SURVEY FOR JOHN, JR. & REBECCA KURTZ

PART OF THE NE. 1/4 OF
SEC. 22, T-22, R-17,
MONROE TWP., RICHLAND
CO., OHIO.

**SURVEYOR'S DESCRIPTION FOR
JOHN, JR. & REBECCA KURTZ**

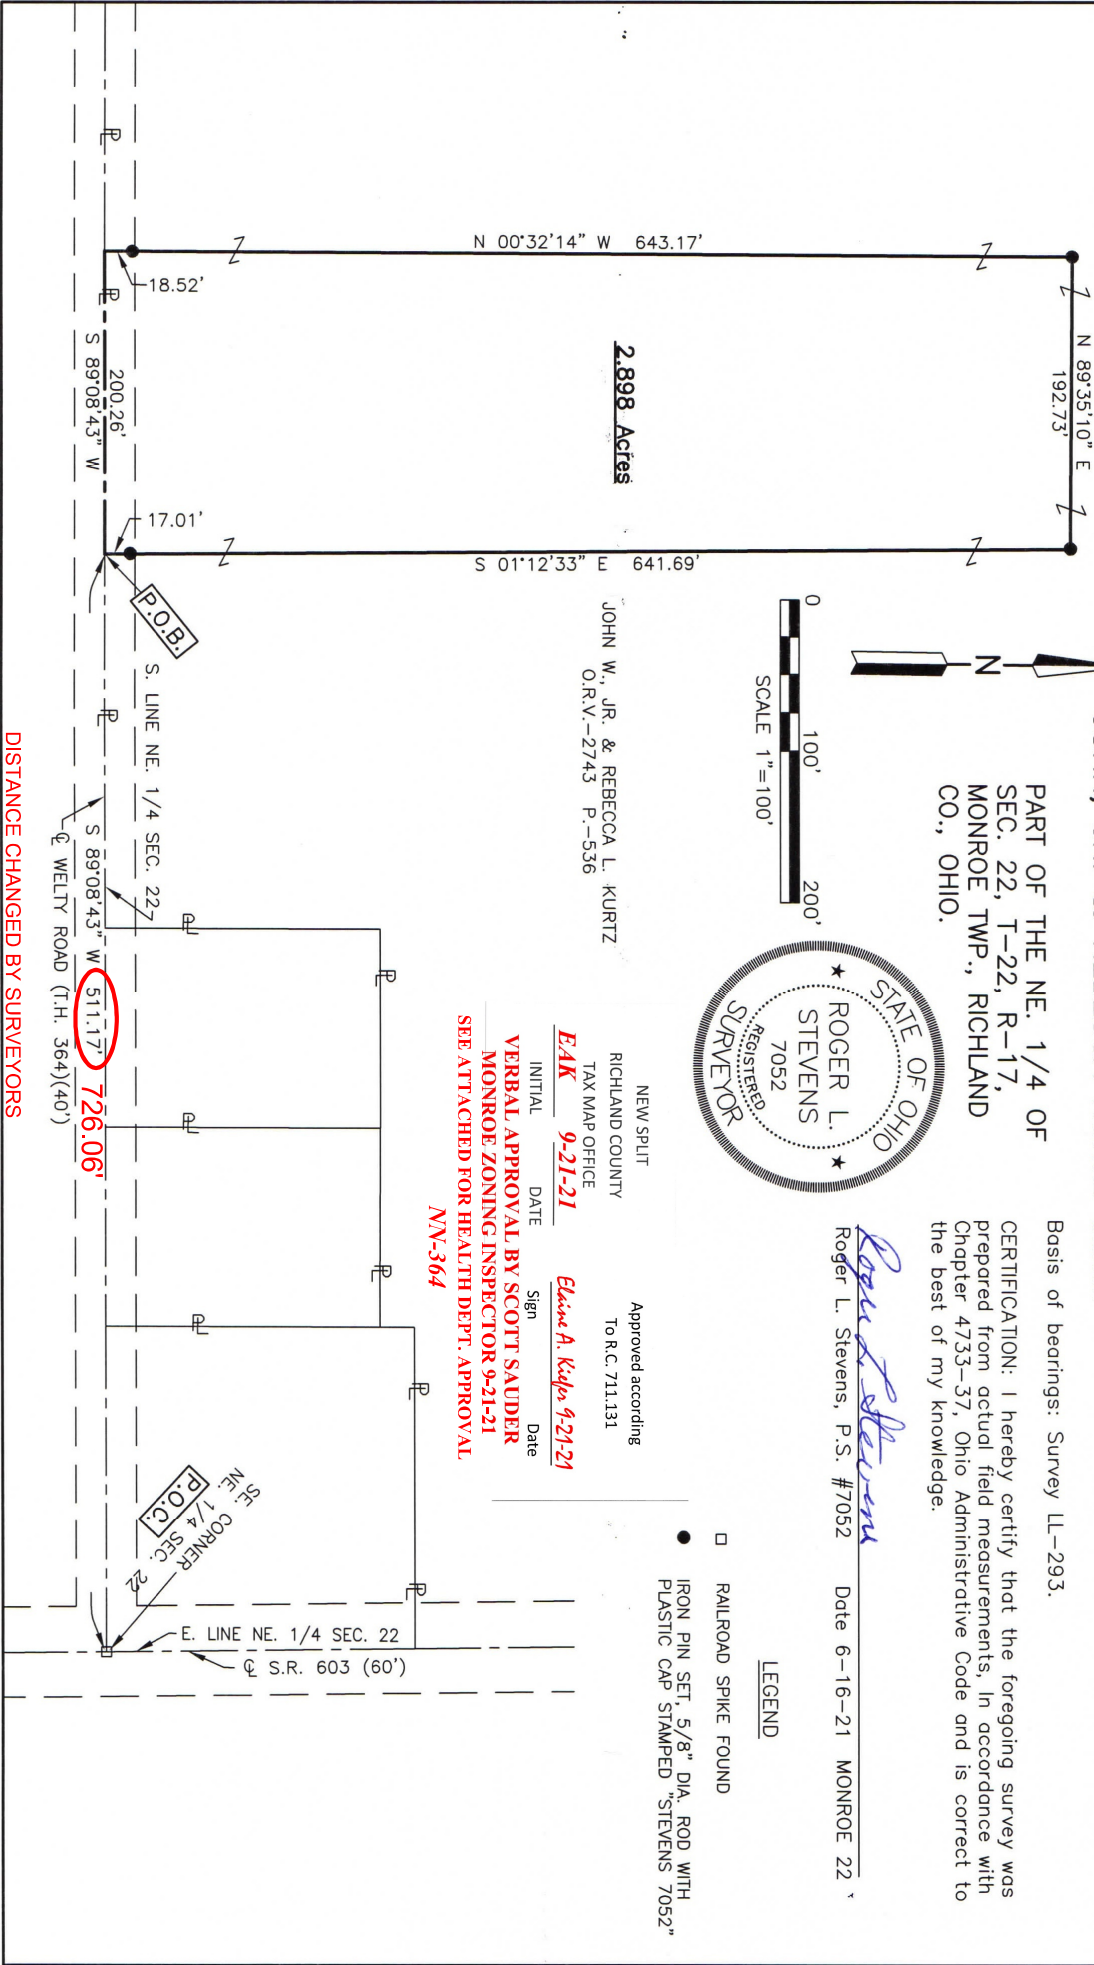
DISTANCE CHANGED BY SURVEYORS
AFFIDAVIT 4-4-23 ORV. 3002, P.643

**DISTANCE CHANGED BY SURVEYORS AFFIDAVIT 4-4-23
726.06' ORV.3002,P.643 SEE ATTACHED FOR CORRECTED LEGAL.**

Thence S 89 ° 08' 43" W, 726.06 feet along the south line of said Northeast Quarter also being along said centerline of Welty Road (T.H. 364)(40') to a point, said point being referenced by an iron pin set N 01° 12' 33" W, 17.01 feet from said point and being the **true place of beginning**;
